27 Primrose
Cherry Chase Village H.D.

HISTORIC PRESERVATION COMMISSION

SUBJECT: Historic Area Work Permit #563857 REVISION

Address:	27 Primrose Street, Chevy Chase	Meeting Date:	11/14/12
Resource:	Contributing Resource Chevy Chase Village Historic District	Report Date:	11/7/12
Applicant:	Kristy and Alex Sternhell (David Jones, Architect)	Public Notice:	10/31/12
Review:	HAWP	Tax Credit:	No
Case Number:	35/13-11P REVISION	Staff:	Anne Fothergill
PROPOSAL: Alterations to garage

SOUTH ELEVATION

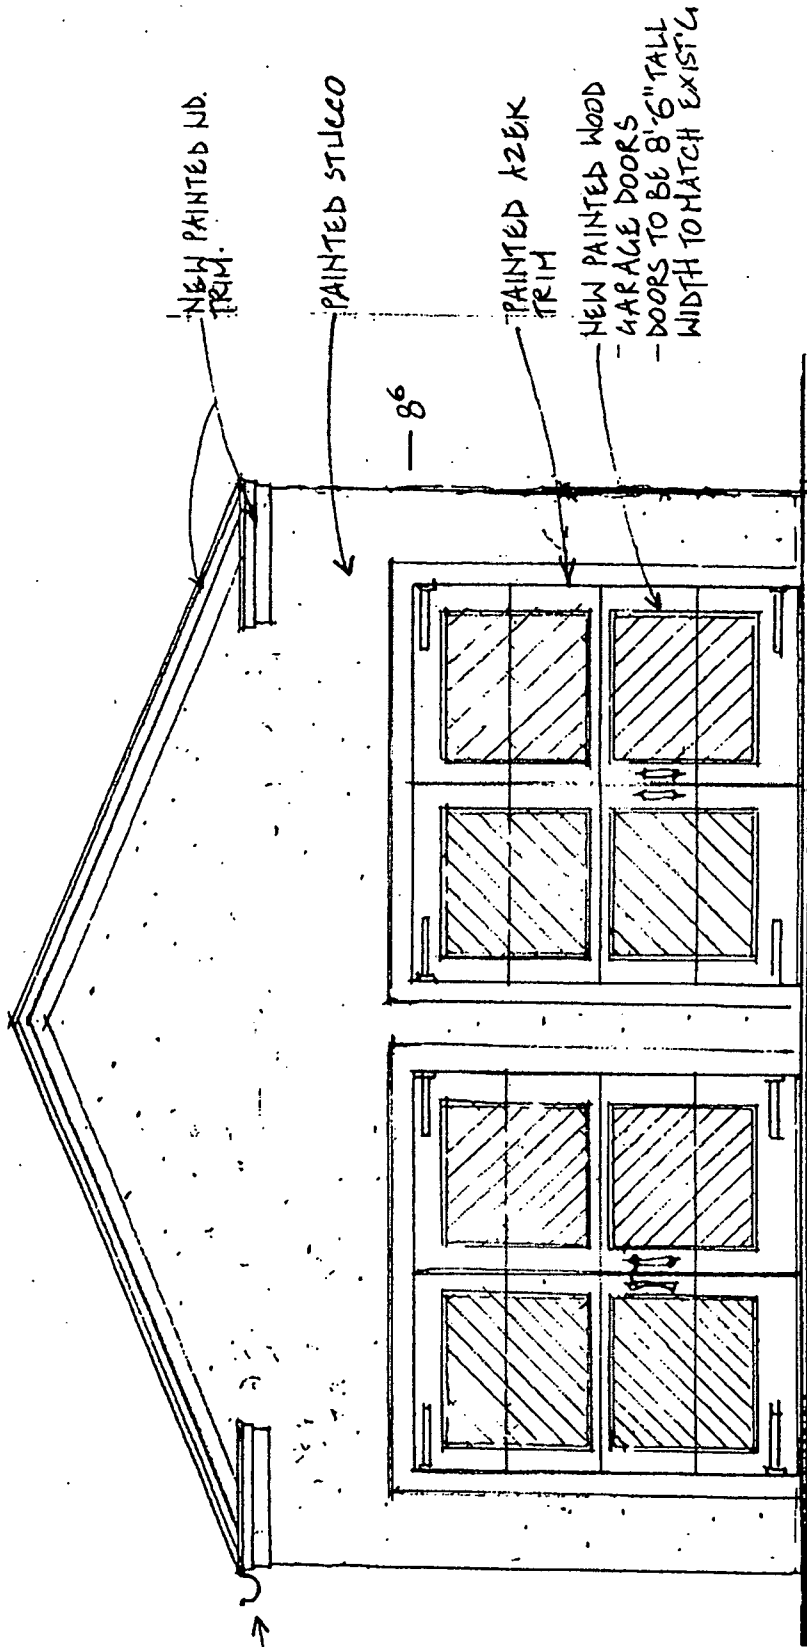
GUTTER THIS SIDE ONLY. MATCH GUTTER ON HOUSE

WEST ELEVATION

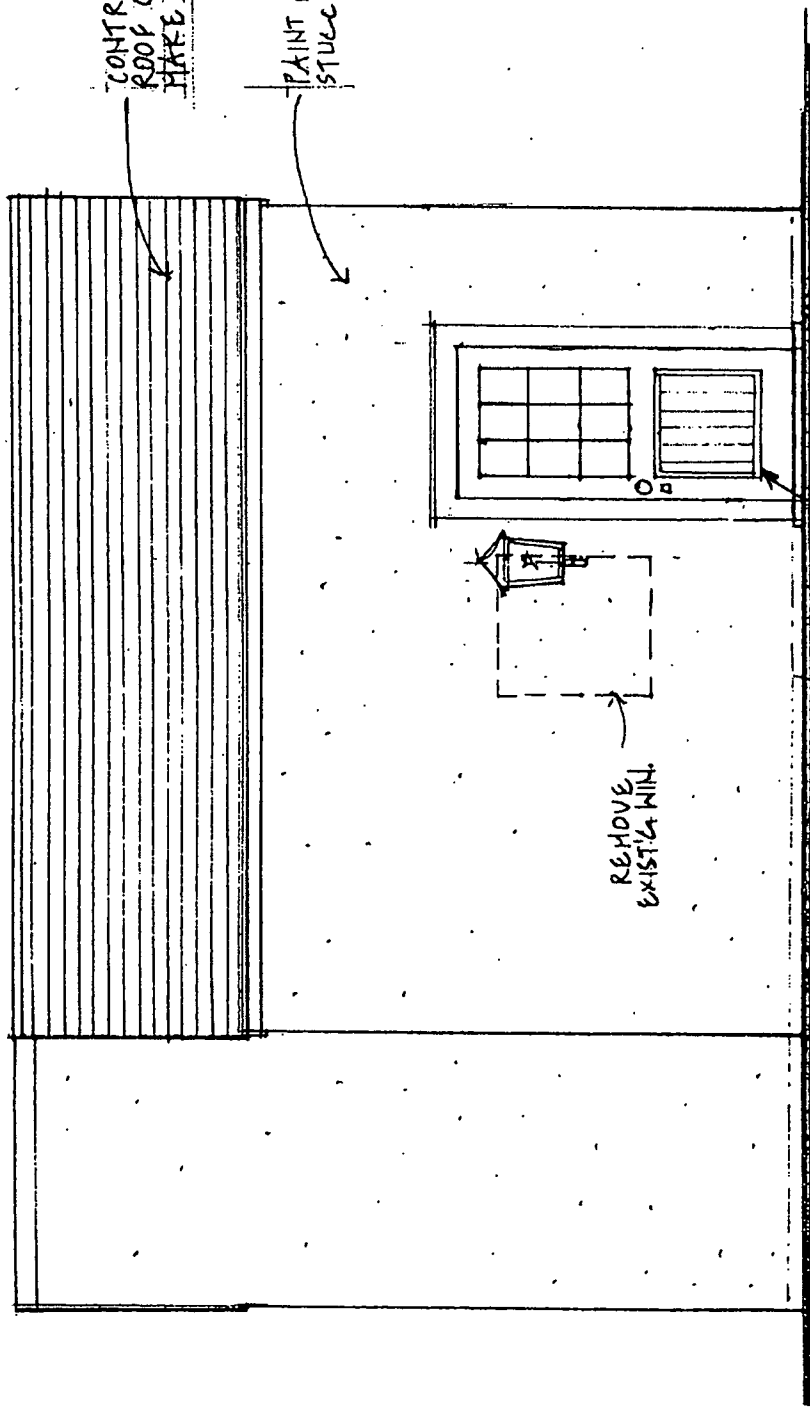
CONTRACTOR TO EXAMINE
ROOF CONDITION &
MAKE RECOMMENDATIONS.

PAINT EXIST'G
STUCCO. PATCH AS NEC. (TYP.)

REMOVE
EXIST'G WIND.

NEW 3' W x 7' T
PAINTED WOOD &
GLASS DOOR

STERNHELL RESIDENCE - EAST ELEVATION 18'-10" · DAVID JONES ARCHITECTS
5.18.11

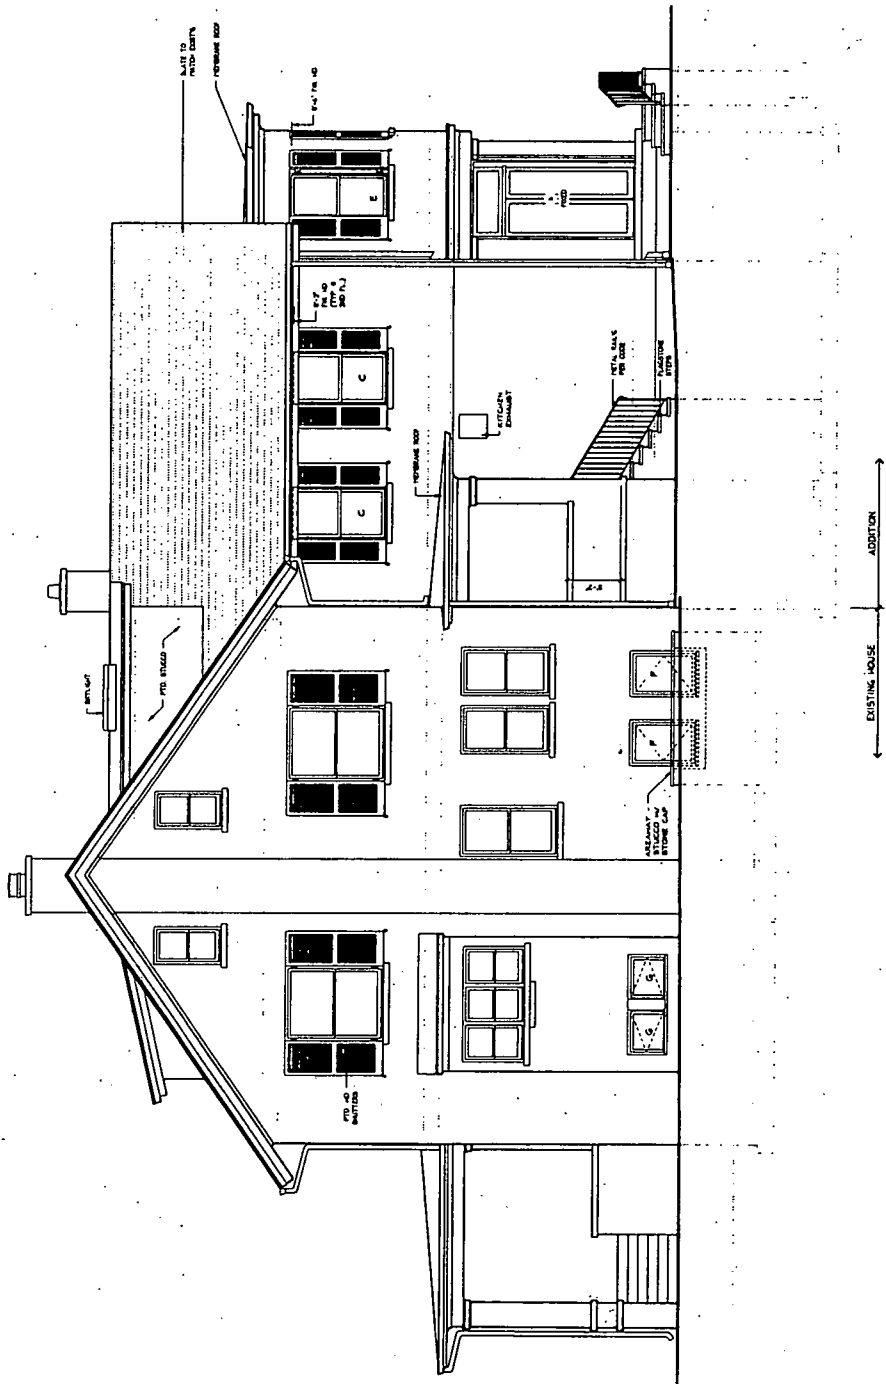
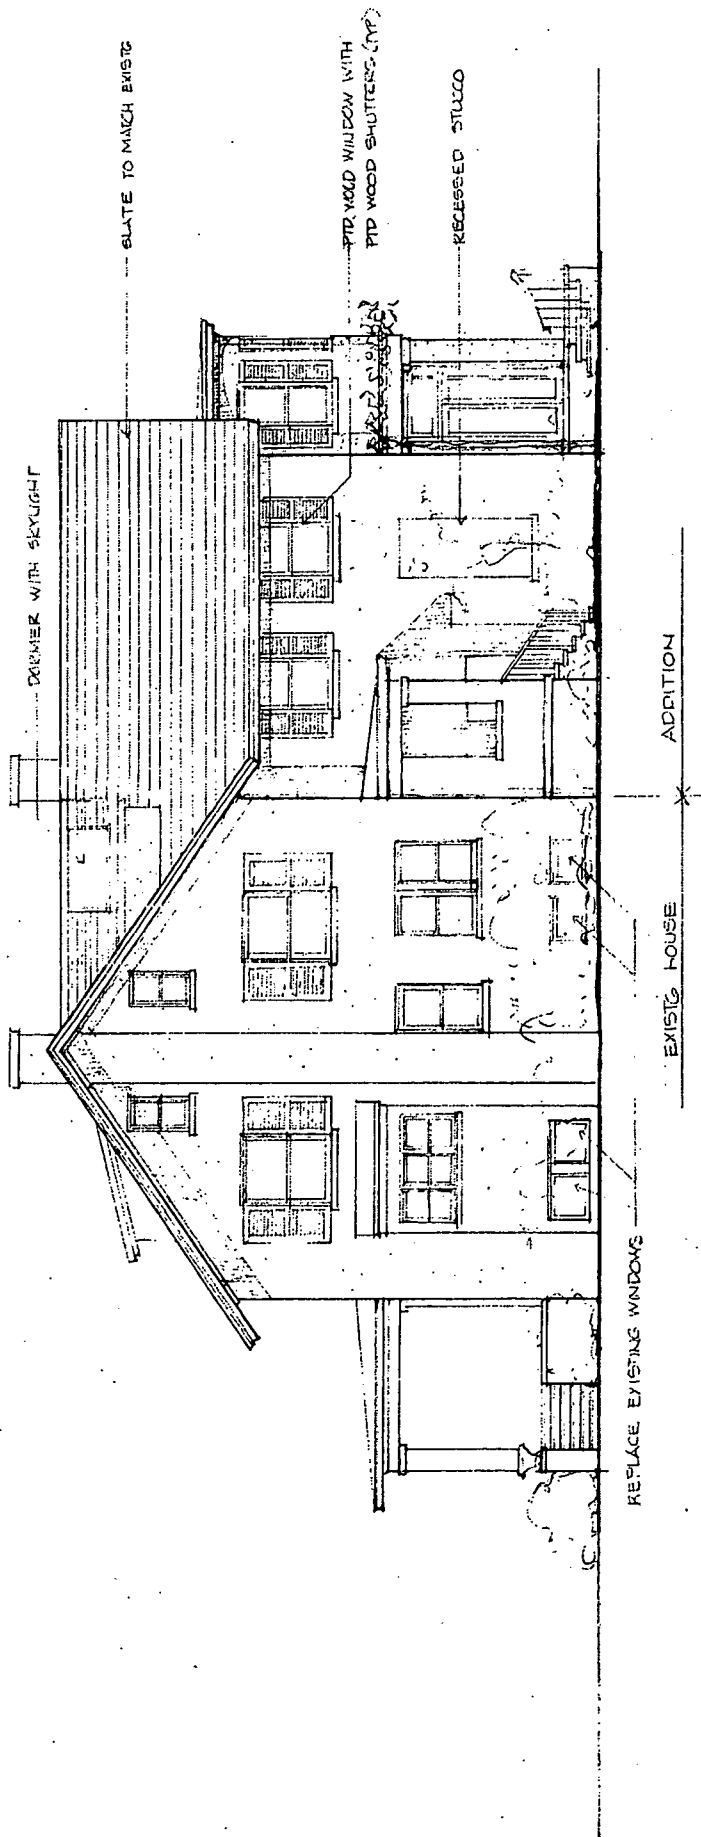
This is a staff item for 27 Primrose and attached are the HPC-approved elevation and the revised elevation. Again, I will print these out in case you don't have time to look at them before the meeting tonight. Thanks, Anne

1. Modify 2 cellar windows and add small areaway for fire egress on east elevation. *(staff note: the HPC approved replacement windows in this location)*
2. Delete stucco recess on addition on east elevation.
